J442™

Issued 1952-01
Revised 2022-05

Superseding J442 FEB2020

Test Strip, Holder, and Gage for Shot Peening

Figure 1A - Standard size test strip

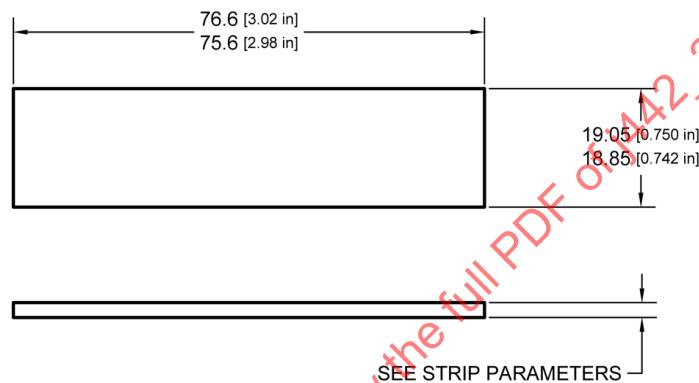
Test strip requirements are now centralized in this document to prevent misinterpretation. This resulted in a high-grade test strip being added to this document in preparation for test strip requirements being removed from AMS2432. Figures 1A and 1B were re-drawn to support two grades of strips. Tables 1A and 1B were added to clarify test strip requirements. A transition period of 18 months has been noted to allow non-conforming strip manufacturers to make acceptable strips.

Figure 2 - Assembled standard size strip holder

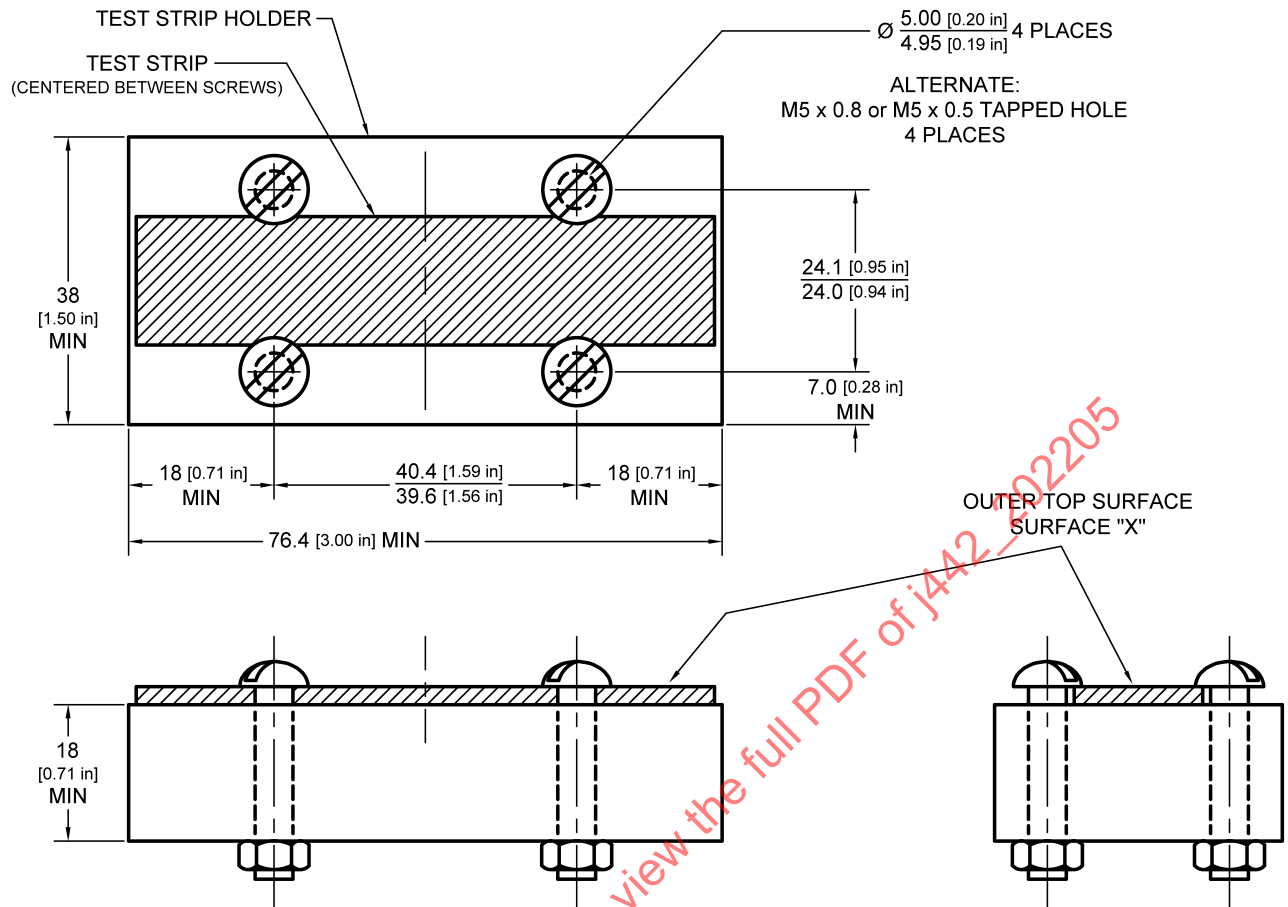
Other changes include removal of conflicting and redundant text. Figure 3 was re-drawn to add inch dimensions for reference while maintaining dimension format/method. The analog gage option was removed from the Figure 3 notes due to requirements outlined in 3.3.1. Side positioning posts that center the test strip along its longer dimension are now required. Figure 4 was re-drawn to correct poor dimensioning in Detail A. Figure 2 was re-drawn to match format of other new figures.
